Addendum No. 005

BID No. 08MOT26, Demolition, LHS-Imperial site, (No DSA) Campus Renovations

ADDENDUM 005 B – Bldgs. A, D, F, H, I Demolition

PROJECT
LUSD – Lynwood High School Demolition Package

drawing no.:
EH-2.1

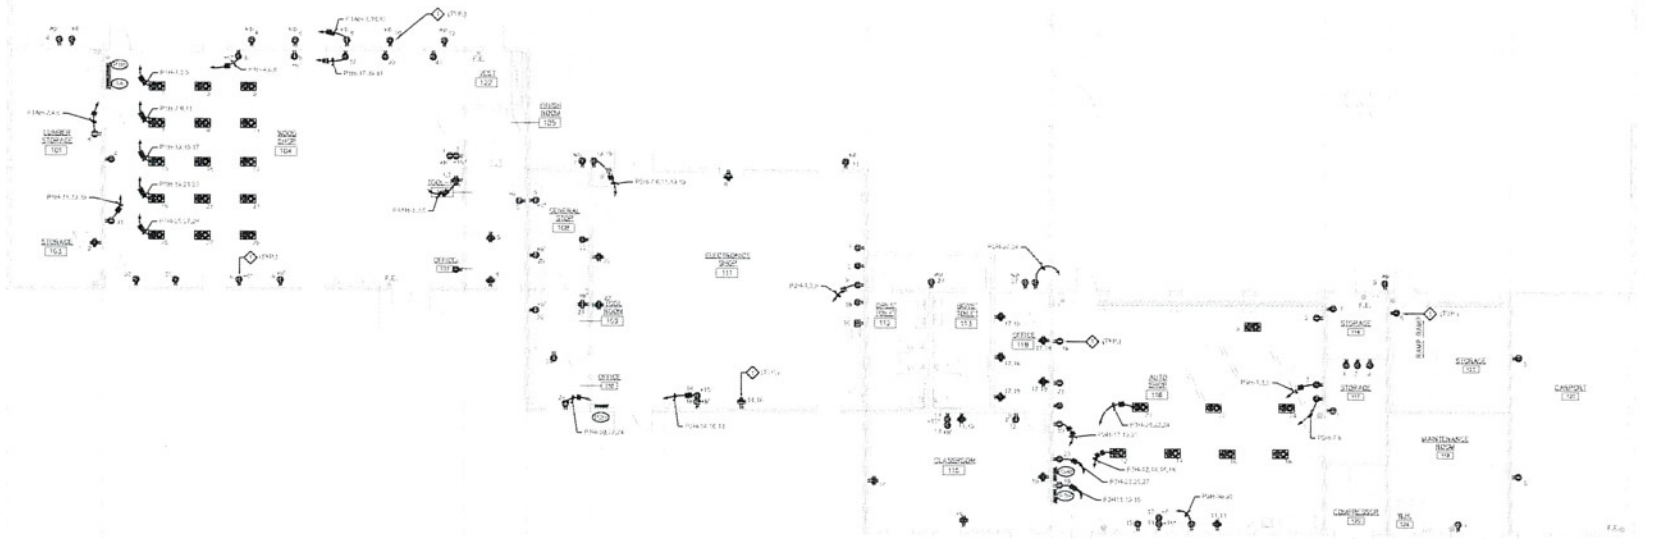
EF-2.2	1. Provided power circuit information. 2. Provided sheet note call outs on plan.	Technical coordination
	EH-2.1	1. Revised type of switches in rooms. 2. Removed fixture tags. 3. Provided lighting circuit information. 4. Provided sheet note call outs on plan.	Technical coordination
	EH-2.2	1. Provided power circuit information. 2. Provided sheet note call outs on plan.	Technical coordination
	EI-2.1	1. Revised type of switches in rooms. 2. Removed fixture tags. 3. Provided lighting circuit information. 4. Provided sheet note call outs on plan.	Technical coordination
	EI-2.2	1. Provided power circuit information. 2. Provided sheet note call outs on plan.	Technical coordination

drawing no.:
FS-101

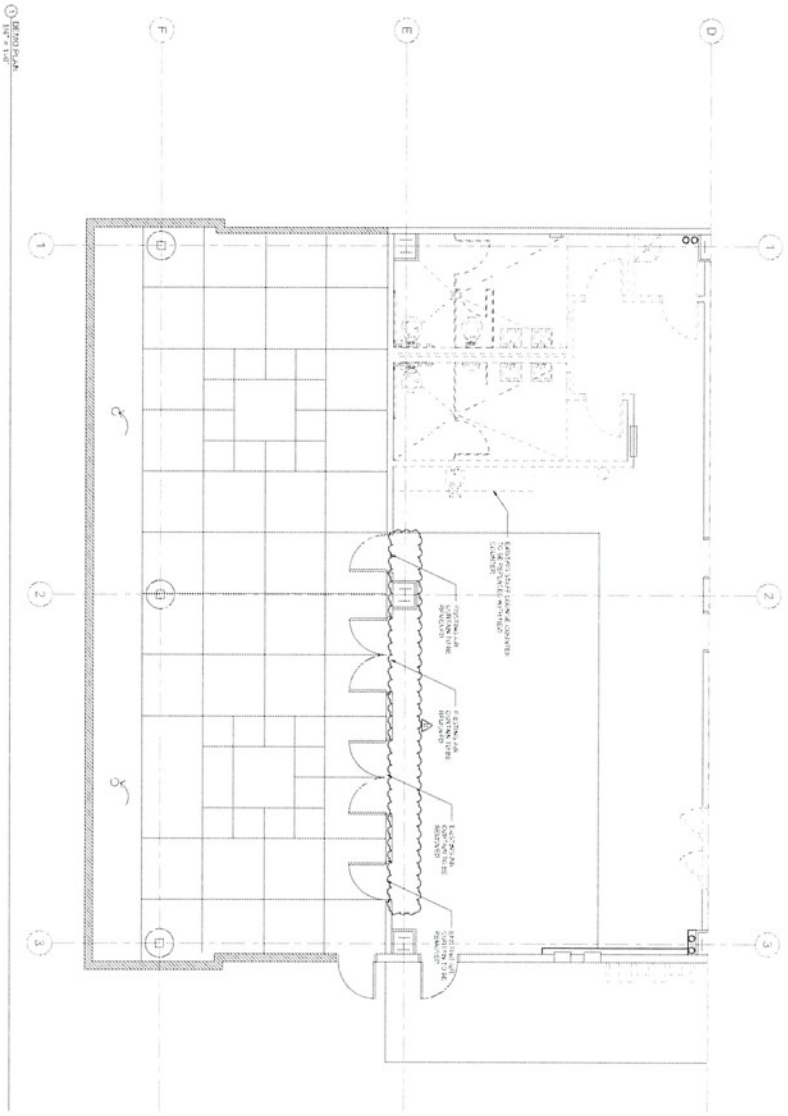
Food Service	FS-101	Walk-Ins to be removed and replaced.	Technical coordination
		Kitchen Hood by ware wash area to be removed.	
		Island Hood to be removed and replaced.	
		Roll thru refrigerator to be removed and replaced.	
		Hand sink to be removed for maneuvering clearance.	
	FS-102	Existing air curtains to be removed.	Technical coordination
Theatrical	TR1.11	Sheet removed from this demolition package.	Technical coordination
	TL1.11	Sheet removed from this demolition package.	Technical coordination
	TL1.12	Sheet removed from this demolition package.	Technical coordination
	TL1.13	Sheet removed from this demolition package.	Technical coordination
